CONSTRUCTION PLANS FOR CARRIAGE MEADOWS SOUTH AT LORSON RANCH

STREET, STORM SEWER, AND POND CONSTRUCTION PLANS

COVER SHEET
STREET, STORM SEWER AND POND
CONSTRUCTION PLANS

SIGNING AND STRIPING PLAN
FONTAINE BLVD &
CARRIAGE MEADOWS DR

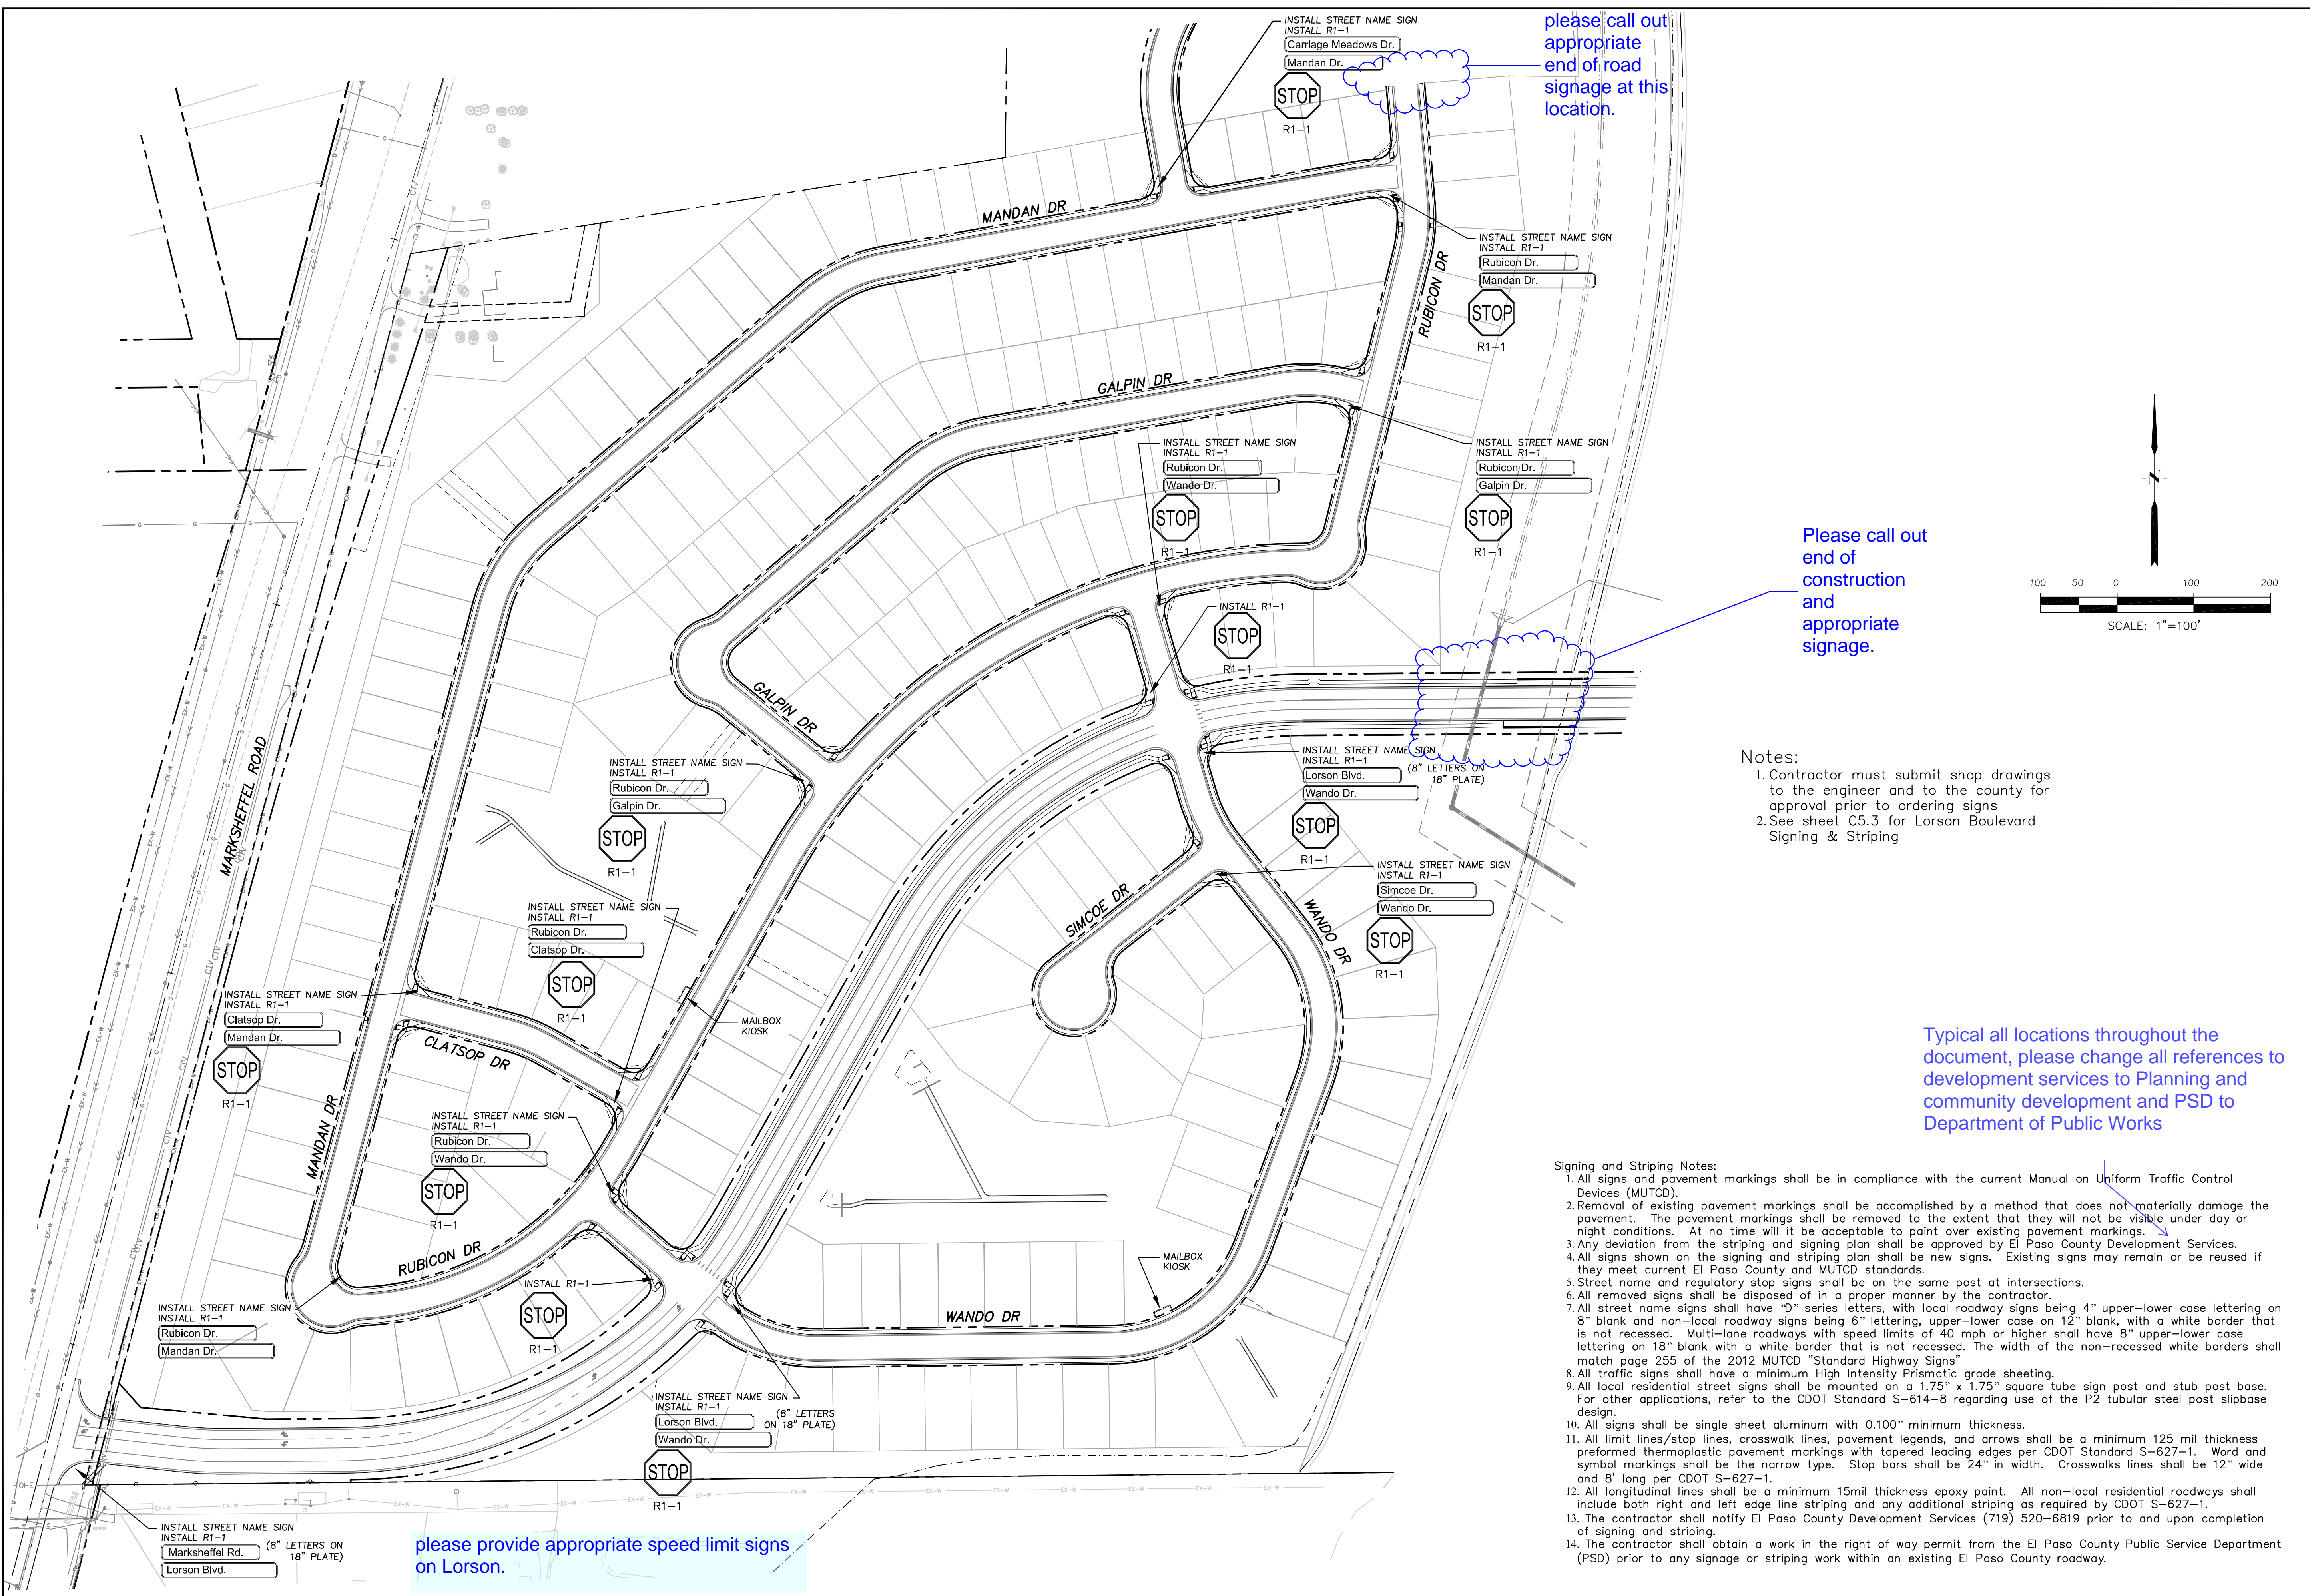
Please clarify that this street is not open at this time. and call out what barricade is existing

Provide 36"X36"

A pedestrian refuge area is required at any location where the crossing length exceeds 48'

provide 36"X36" sign

Change to PCD and DPW

SIGNING AND STRIPING PLAN
CARRIAGE MEADOWS SOUTH

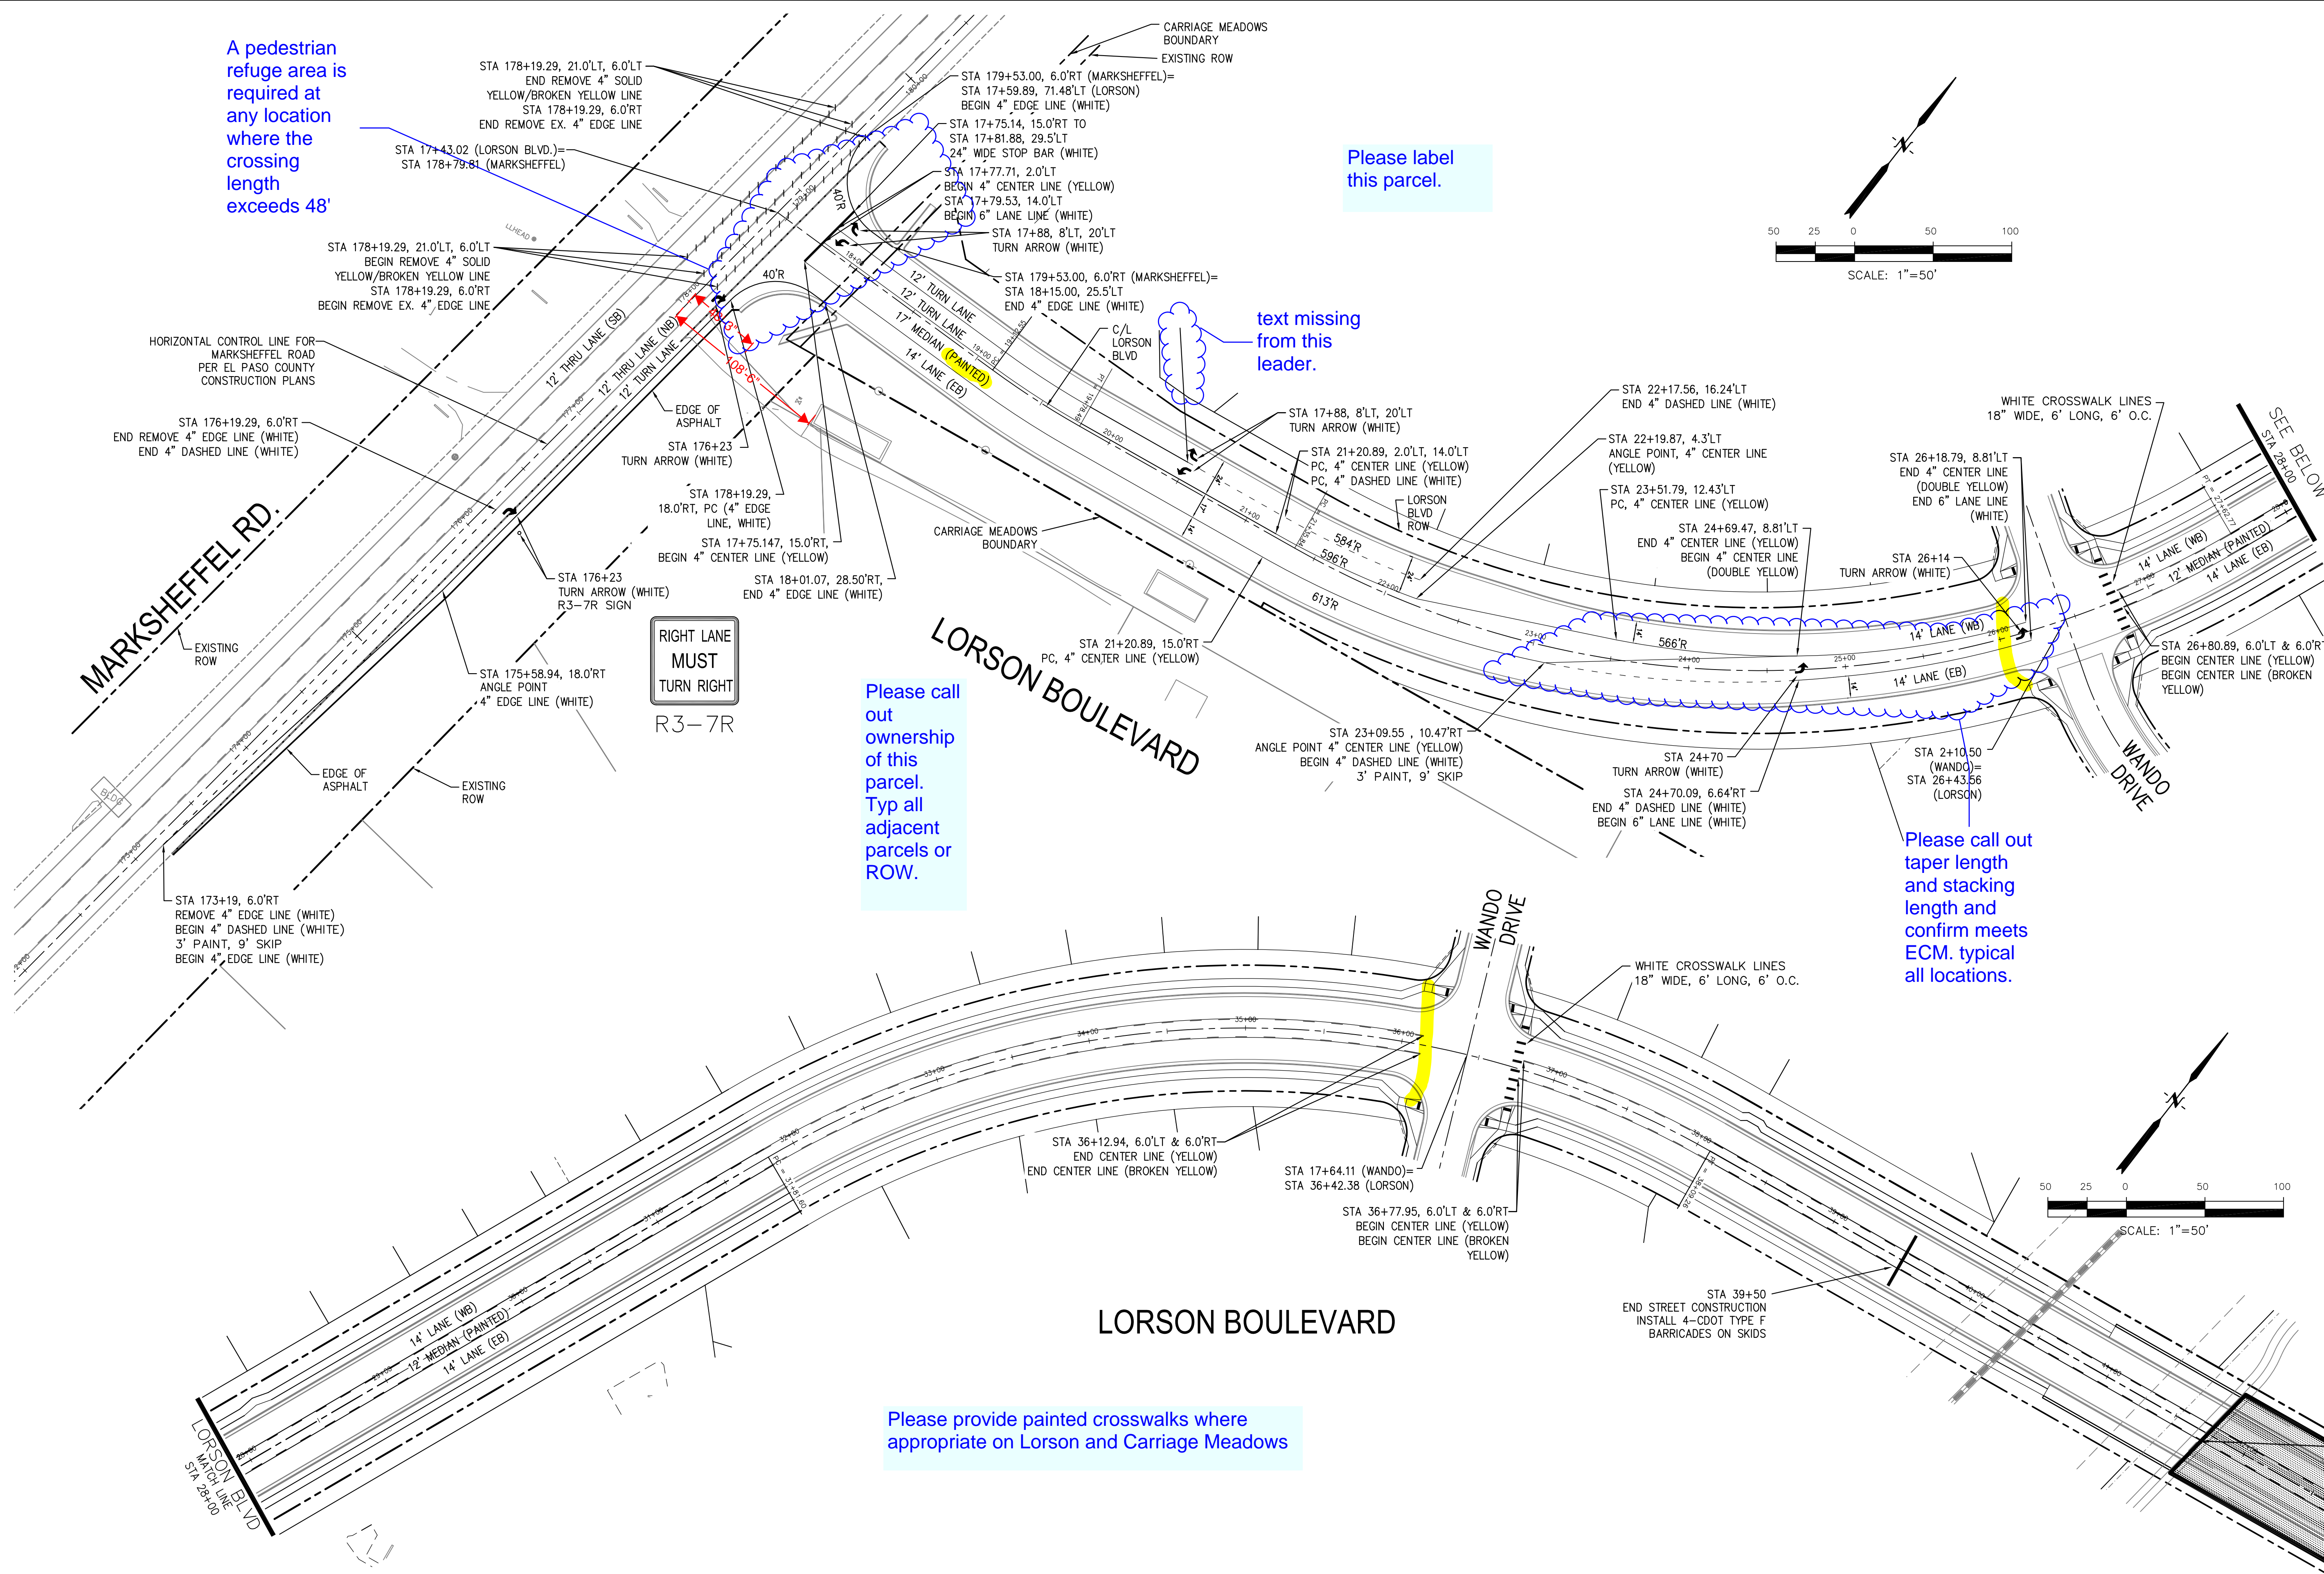
please provide appropriate speed limit signs on Lorson.

Typical all locations throughout the document, please change all references to development services to Planning and community development and PSD to Department of Public Works

A pedestrian refuge area is required at any location where the crossing length exceeds 48'

Please label this parcel.

text missing from this leader.

Please provide painted crosswalks where appropriate on Lorson and Carriage Meadows
